The Greater Cambridge Design Review Panel

Brookmount Court, Cambridge

(PPA/22/0019)

27th October 2022

Proposed Ground Floor Plan – extracted from the applicant’s presentation document

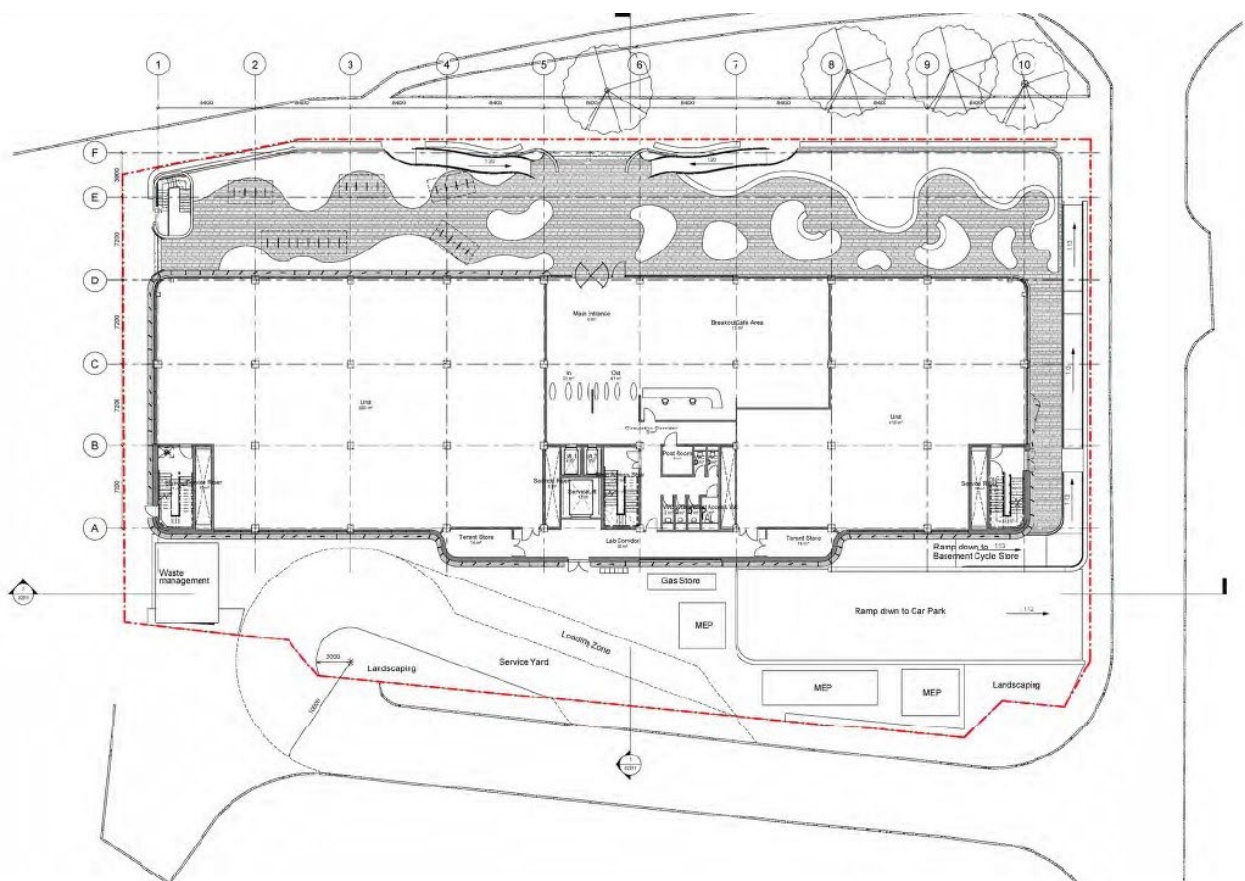
Noting that the applicant team is aiming to reinforce streetscape nature with the project, there is also a wonderful opportunity for community interaction at street level. In the Panel's view, there should be no barrier to the public entering the landscaped space currently shown on the podium. But while it is laudably intended to be welcoming and stated that the public can easily access the space, the actual relationship between the public and private realm and the transition between them via the podium does not seem to work yet. The Panel acknowledges that it is problematic to do more in design terms when there is no known end user for the building and security may be an issue; it is accepted that the extent to which the frontage landscaping can be 'open and welcoming' may change. As currently designed however, the Panel is uncertain as to how often, and where the building's users and the public will make use of it. The new public realm is north-east facing and although it will be possible for landscaping to work here, it will have its own

microclimate and will be quite dark and cool, such that it is likely to be less inviting than intended. There is also a tension with providing public space on Kings Hedges Road (or alternatively at its junction with Kirkwood Road), in the ways being suggested for employees, visitors and the local community, as both locations are on roads that are busy at certain times of day.

At present, the proposal gives little to the street; consideration could be given to creating space for e.g. food vans for increasing daytime activation. A link with the Daily Bread Cooperative in Kilmaine Close e.g., welcoming them into the ground floor of the building as a public use could also prove highly successful.
